SUGAR HILL | JOHN R & FOREST

MOSAIC HOMES

CHAD GOULD ARCHITECT LLC ©2019

August 28, 2021

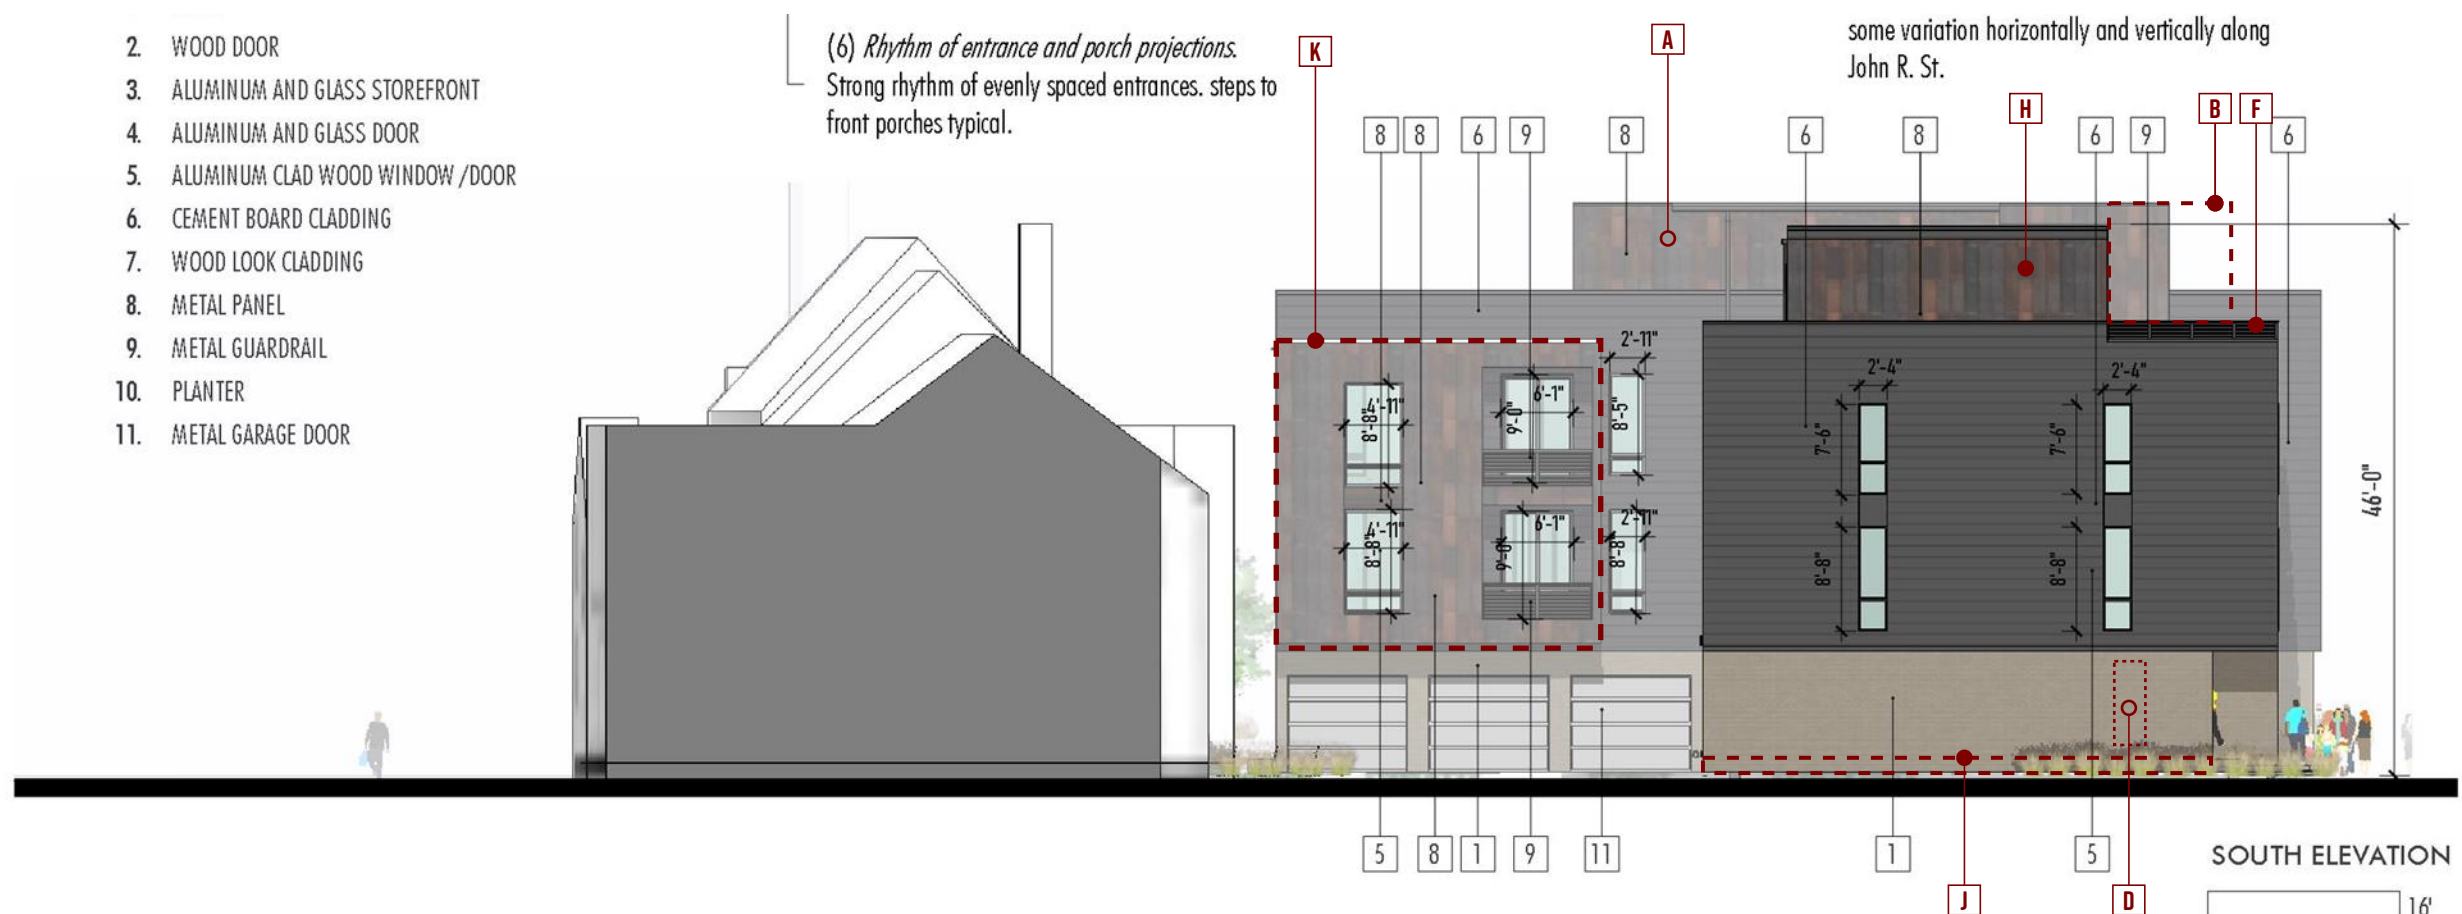
- A EXPANDED COVERED ROOFTOP AREA.
- B ELIMINATED STAIR TO ROOFTOP.
- C ADDED WOOD LOOK SIDING BETWEEN WINDOWS.
- D REVISED WINDOW.
- E ELIMINATED BALCONIES ON THIRD FLOOR.
- F REVISED GUARDRAIL FROM GLASS TO METAL.
- G ENCLOSED COVERED ROOFTOP DECK.
- H REVISED CEMENT BOARD LAP SIDING TO METAL SIDING.
- I REVISED DOOR STYLE FROM FULL GLASS TO WOOD.
- J ELIMINATED PRECAST BASE REPLACE WITH BRICK
- K REVISED BALCONY AREA PER ADDED BEDROOM.

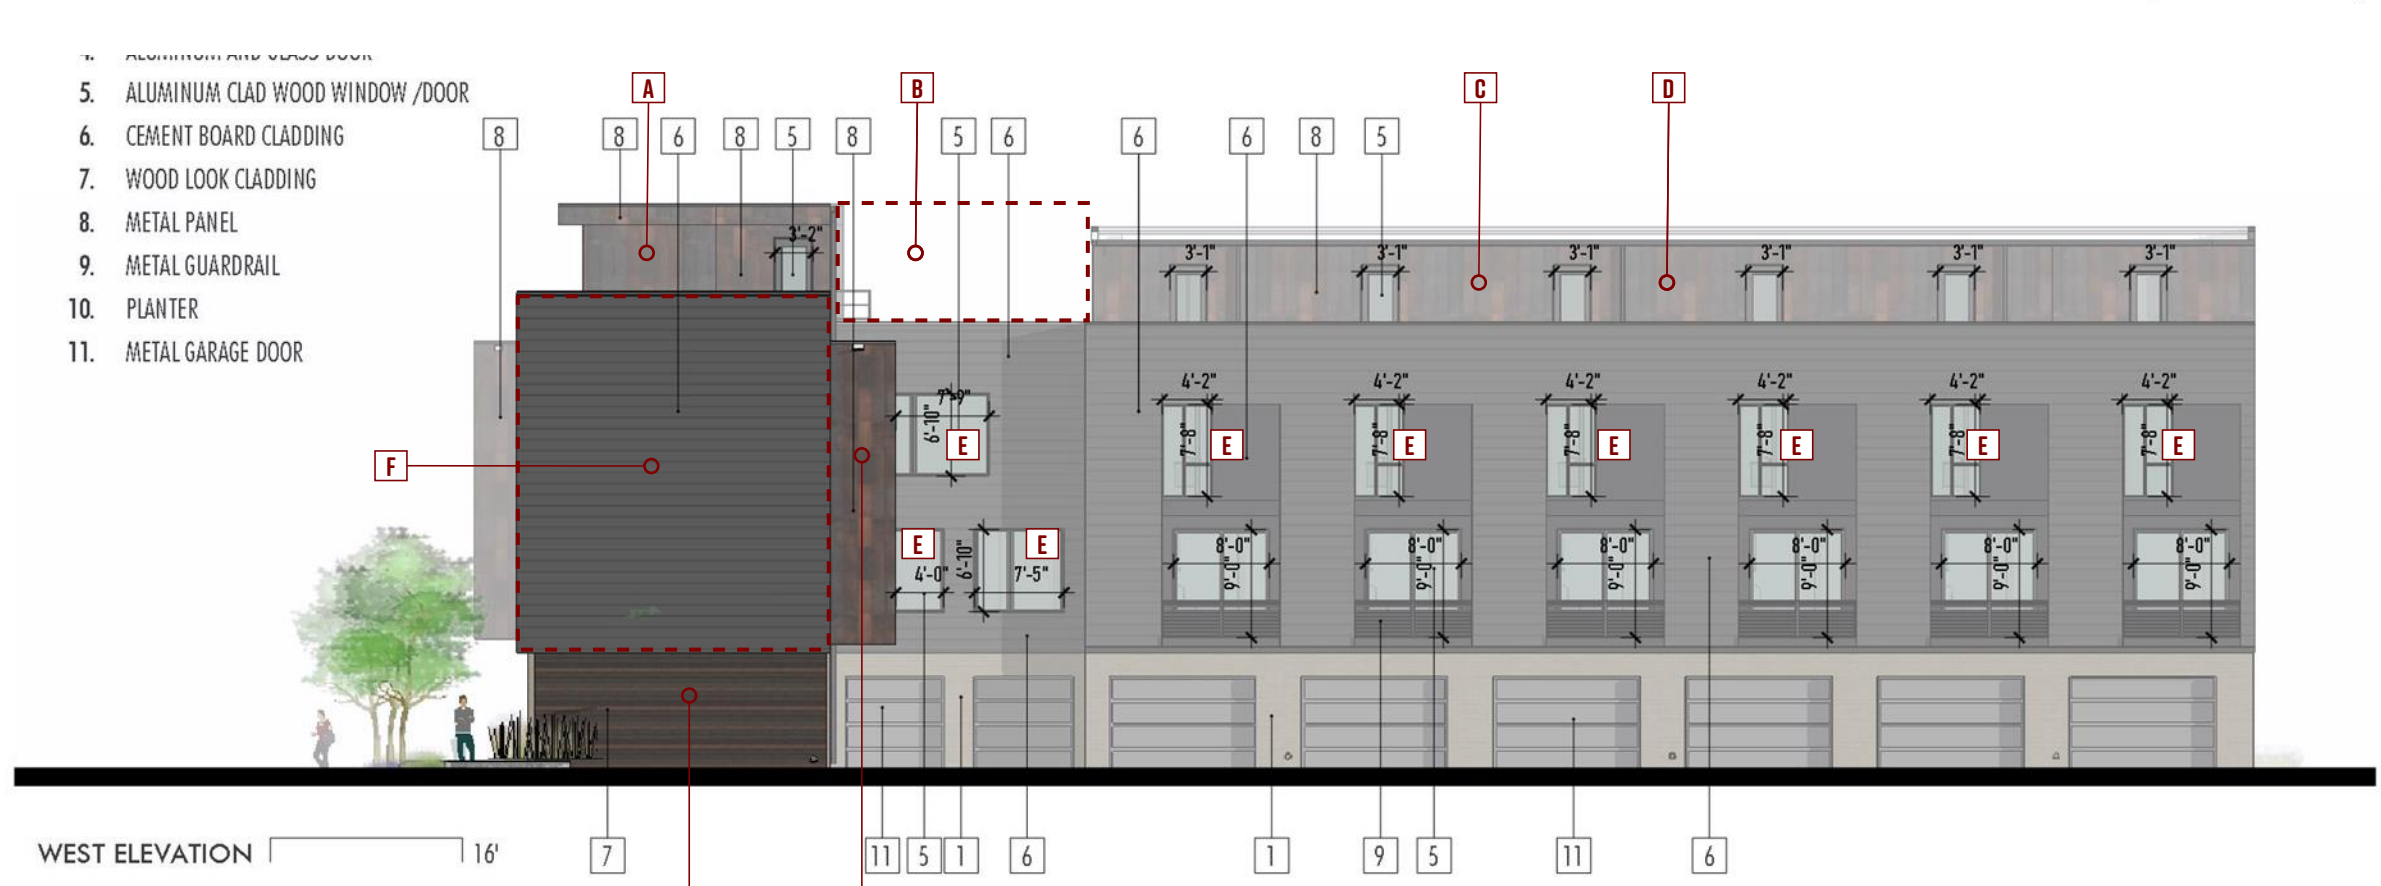
- A EXPANDED COVERED ROOFTOP AREA.
- B ELIMINATED STAIR TO ROOFTOP.
- C ENCLOSED COVERED ROOFTOP DECK.
- D REVISED CEMENT BOARD LAP SIDING TO METAL SIDING.
- E REVISED WINDOW
- F ELIMINATED WINDOWS PER BUILDING CODE. TOO CLOSE TO PROPERTY LINE
- G REVISED FROM BRICK TO WOOD LOOK METAL SIDING.
- H REVISED BALCONY AREA PER ADDED BEDROOM.
